ARCHITECTURAL REVIEW BOARD REGULAR MEETING AGENDA

Agenda Item: **APPLICATION FOR NEW CONSTRUCTION, ARB #25-001, to consider an application for the construction of a new restaurant, Pollo Campero, with a drive-thru, located at 1131 Elden Street, Herndon, Virginia.**

Subject: Architectural and Urban Design Review of 1131 Elden Street, Pollo Campero

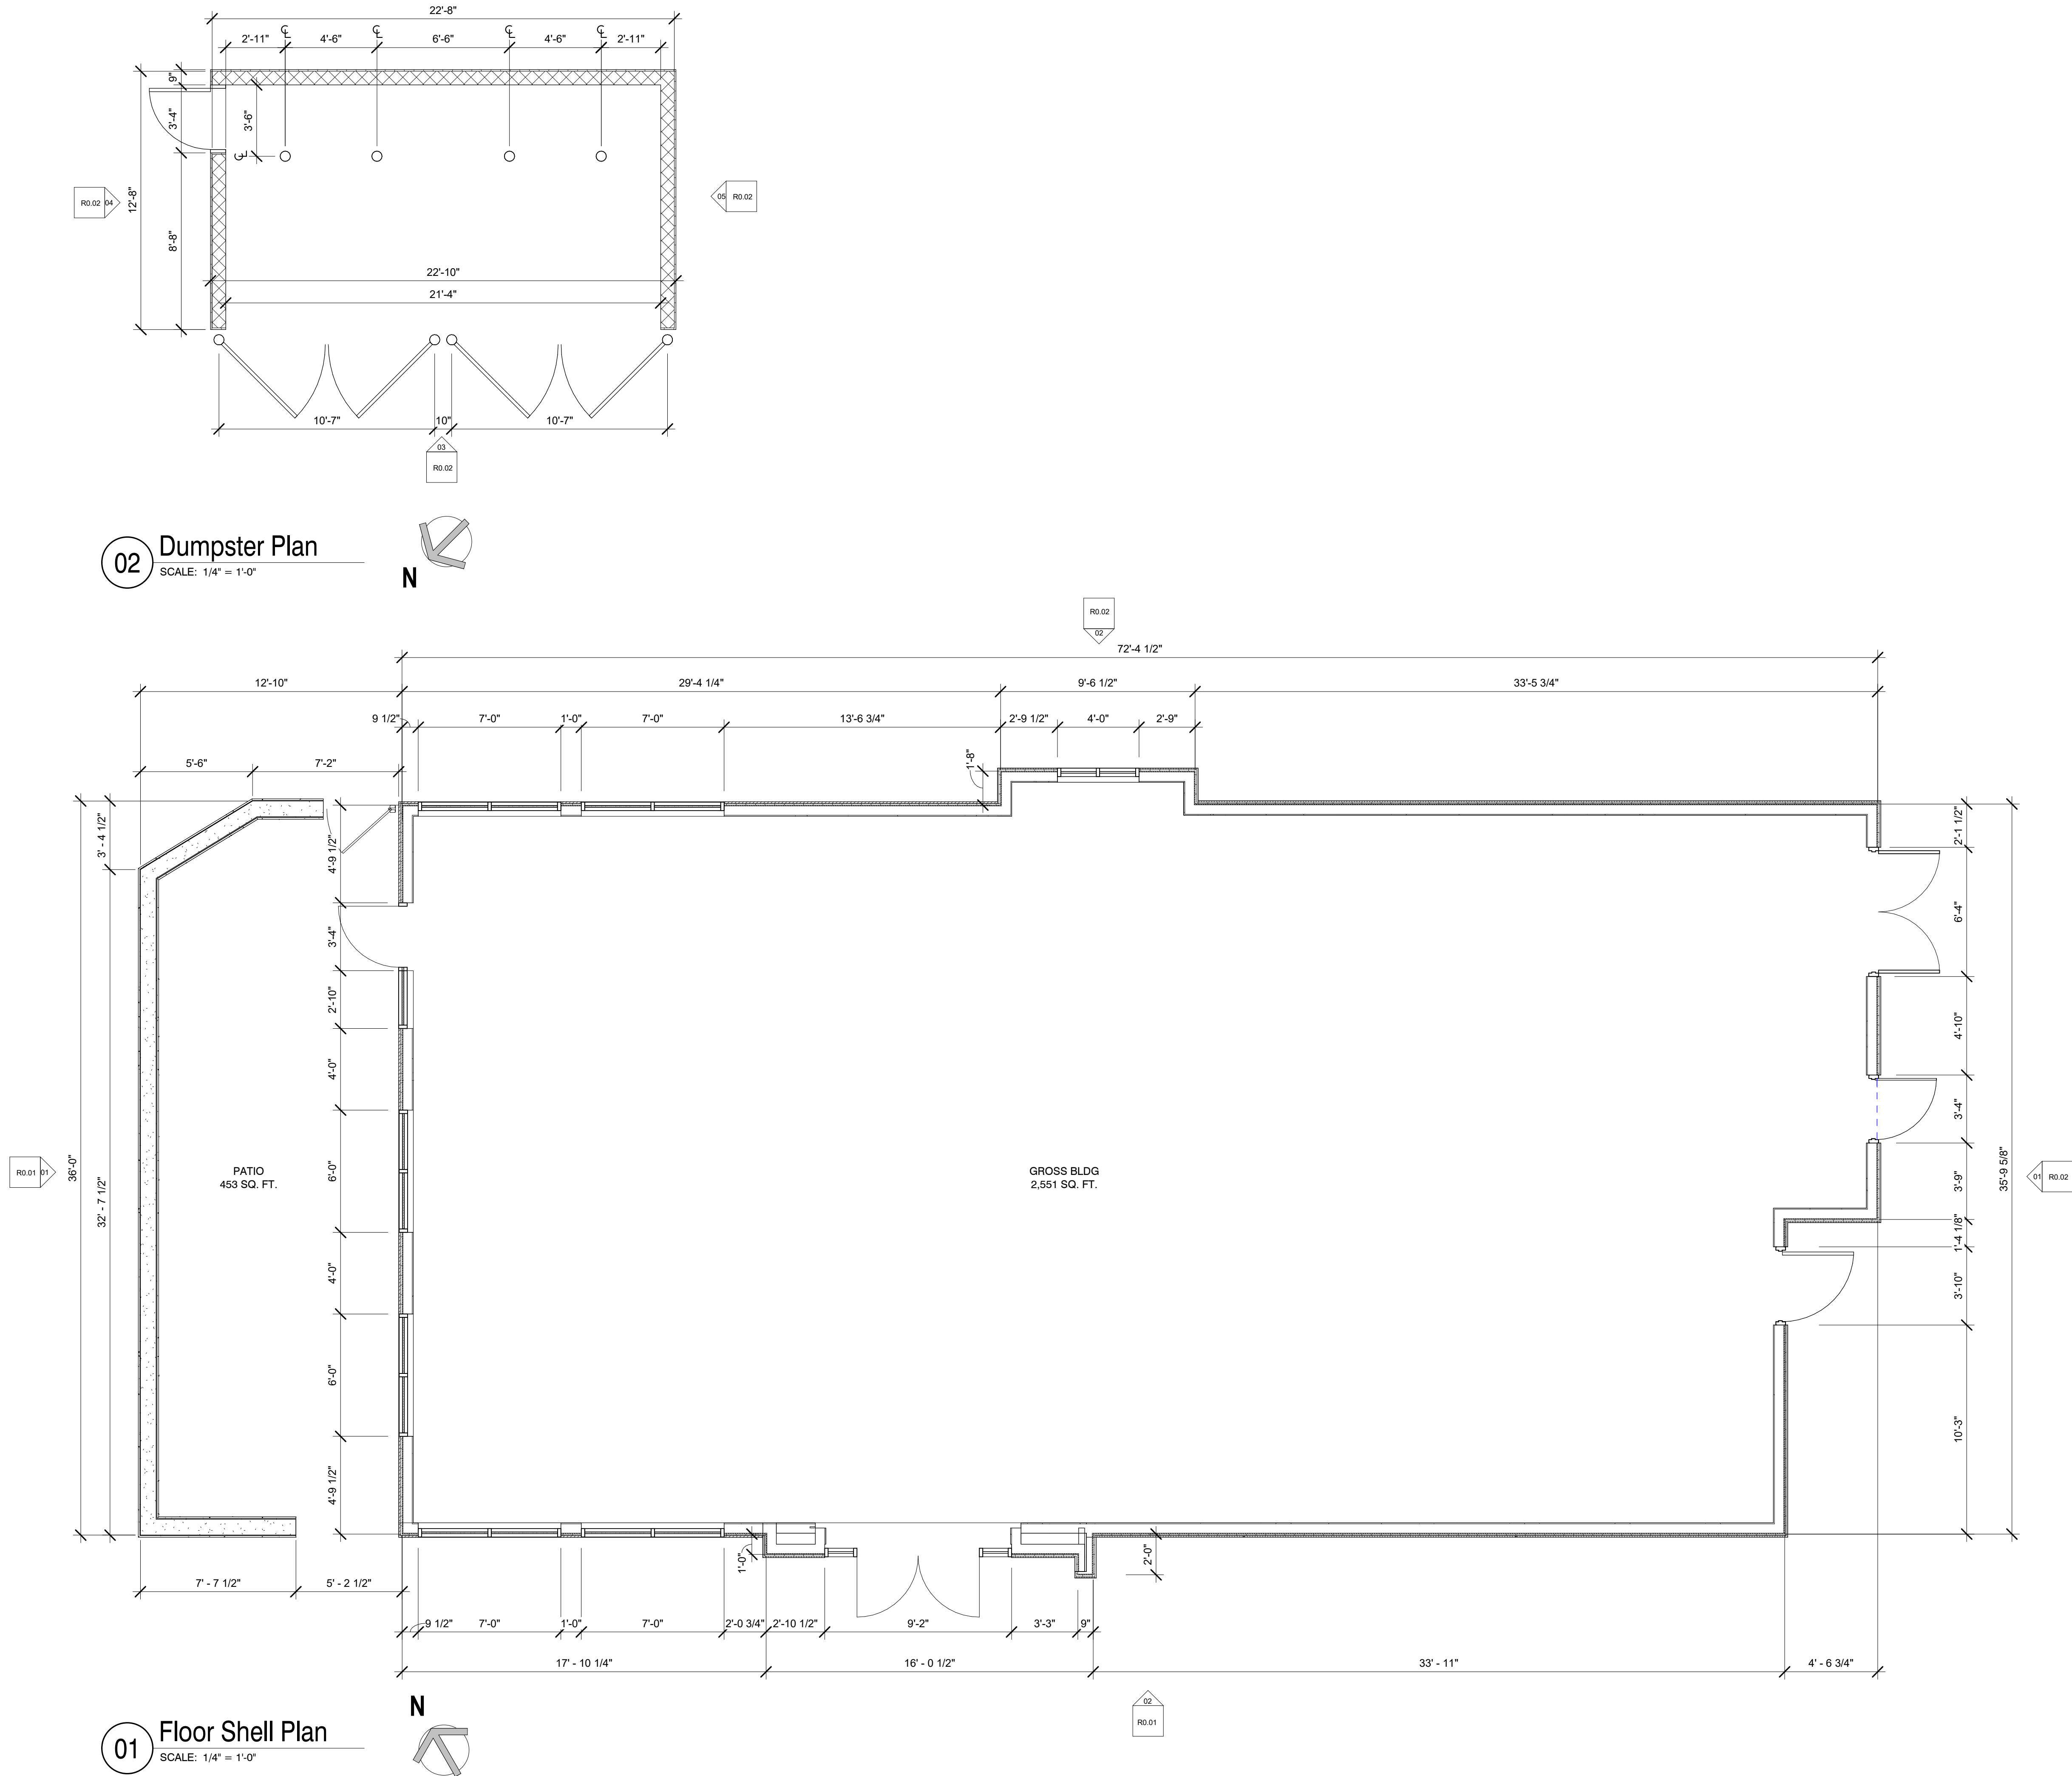
7. **Prior Revised Design.** In 2021, the applicant provided staff with a draft revised design, shown in the illustration below. This design was not reviewed by staff or provided to the ARB but is worth viewing to understand the possible ways in which items raised in this report and the previous memo may be addressed.
